19 December 2025

SUBMISSIONS: STO8-1: EP161 Beetaloo Basin Appraisal Pilot Environment Management Plan

Figure 33 - One per cent AEP flood inundation areas at Jibera South

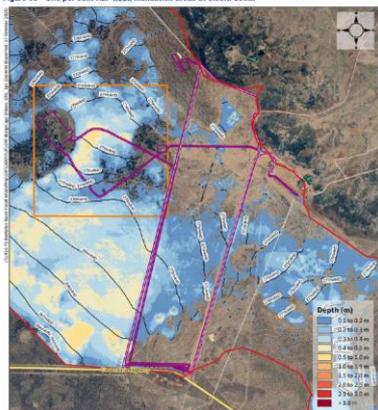
86. ECNT notes that both of the proposed well pads (and indeed much of EP 161) are located in the middle of a floodplain. Santos has modelled the impacts of 1 in 100 year flooding events in assessing the risk of flooding. ECNT notes that this level of flooding would effectively surround the well pads with floodwaters, some of this water flowing a reasonably high velocities (see image below with respect to Jibera South). This raises serious questions about the ability of Santos to expand fracking operations in this area, and also raises the risk profile regarding spills from the current activities significantly.

87. ECNT notes that 1 in 100 year flood modelling may not be appropriate for this site. It is unclear, for example, how many years of data Santos is relying upon in using this modelling, and it is possible that this data does not contain the largest possible events that could occur in terms of rainfall. Climate change is influencing how often flooding occurs, and rainfall events are expected to become more intense in the future in the Northern Territory. In ECNT’s view, Santos should be required to assess flood risk using a 0.1% Annual Exceed Probability (1 in 1000 year) modelling standard.
